MPC5777M Reference Manual

MPC5777M Reference Manual, Revision 4.2

Document Number: MPC5777MRM
Rev. 4.2, 08/2016

The updates for MPC5777M RM Rev 4.2 are described in detail below.

Figure 2-1. Block diagram

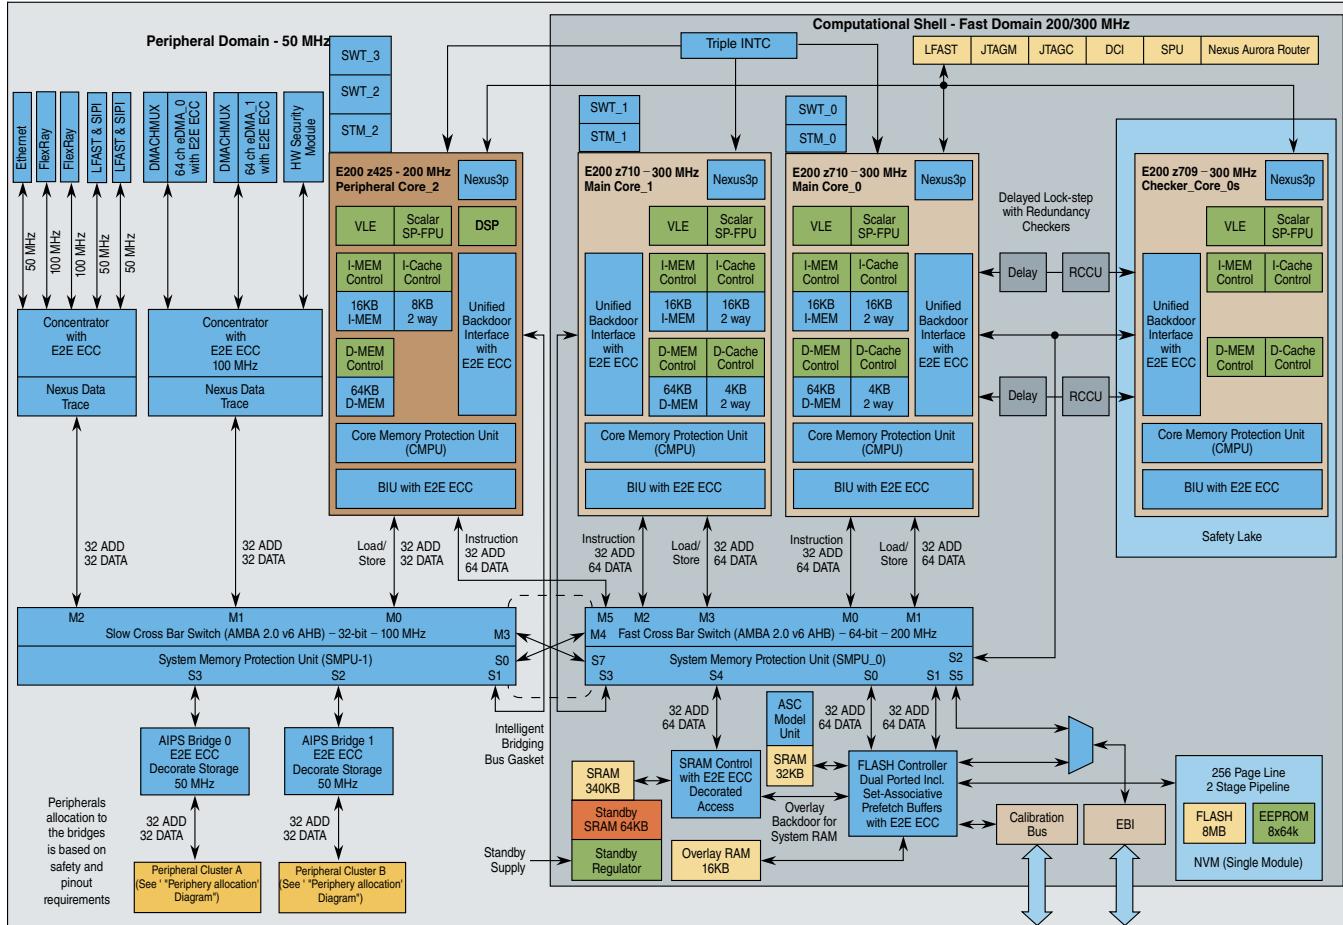
- The Block Diagram is updated. The 'Concentrator with E2E ECC 50 MHz' changed to 'Concentrator with E2E ECC' and the connection arrows from the FlexRay Ethernet and LFAST & SIPI now have the frequency listed on them.

Figure 2-4. Error signal flow

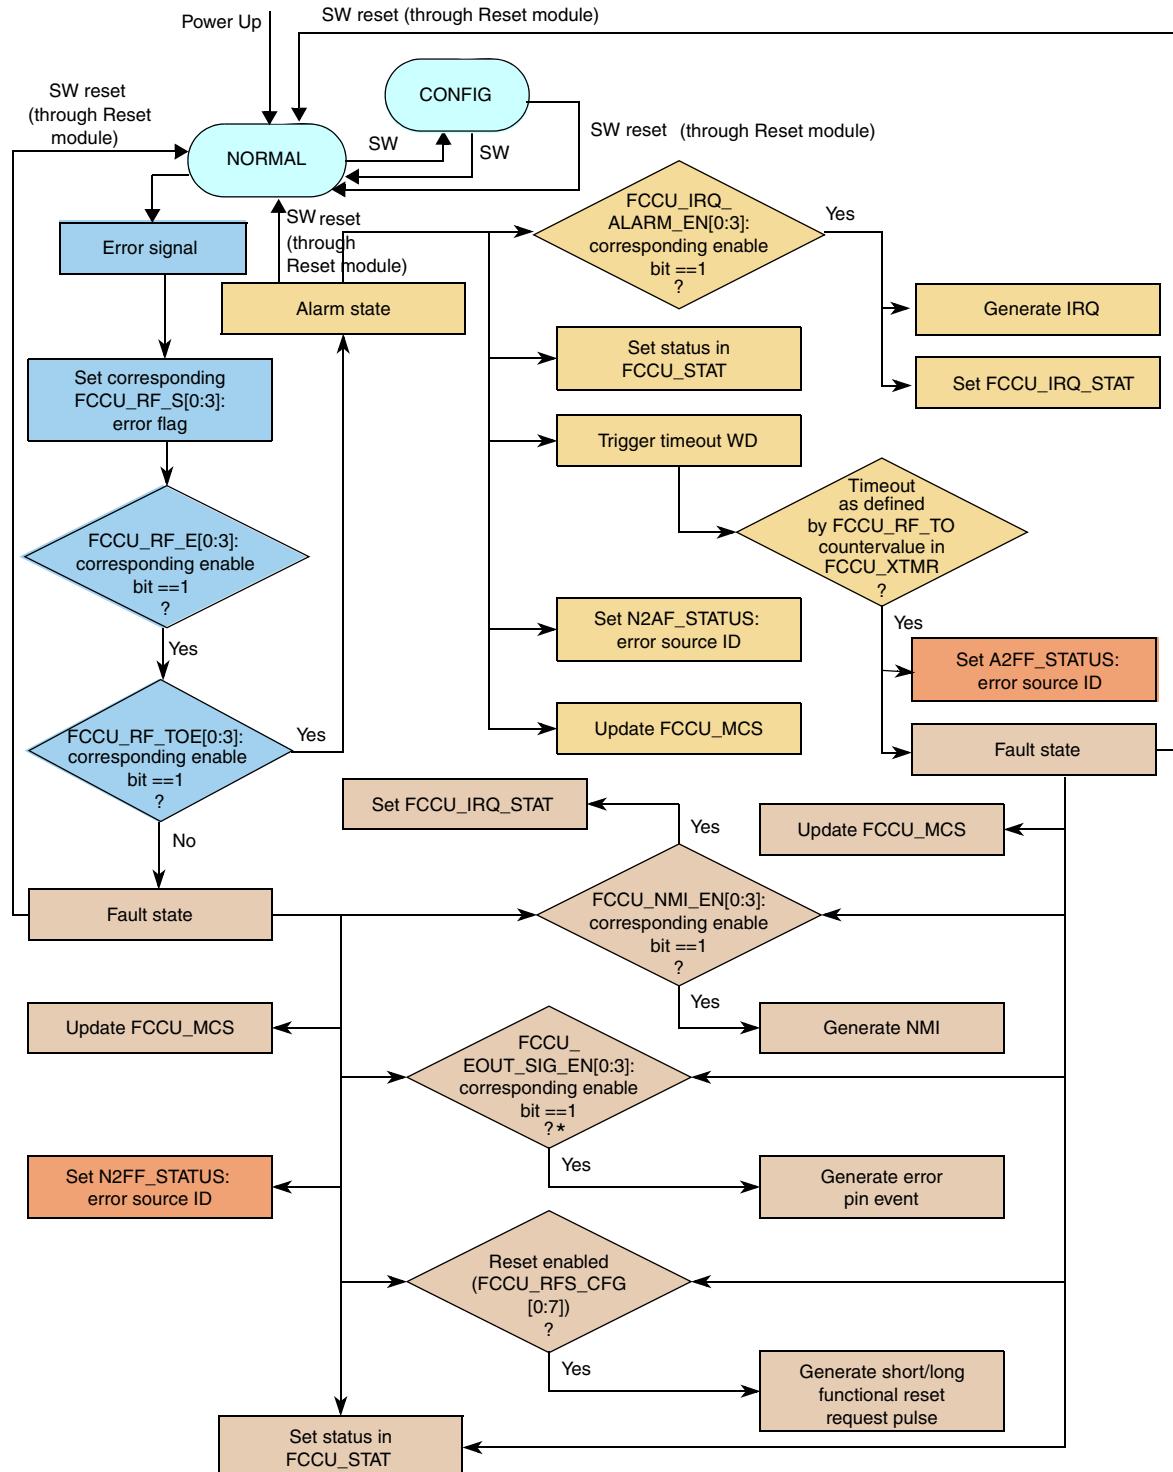
In the [Figure 2-4](#), added a footnote 'This condition must be satisfied only when FCCU is configured for Bistable fault-output mode (FCCU_CFG[FOM])'.

* This condition must be satisfied only when FCCU is configured for Bistable fault-output mode (FCCU_CFG[FOM]).
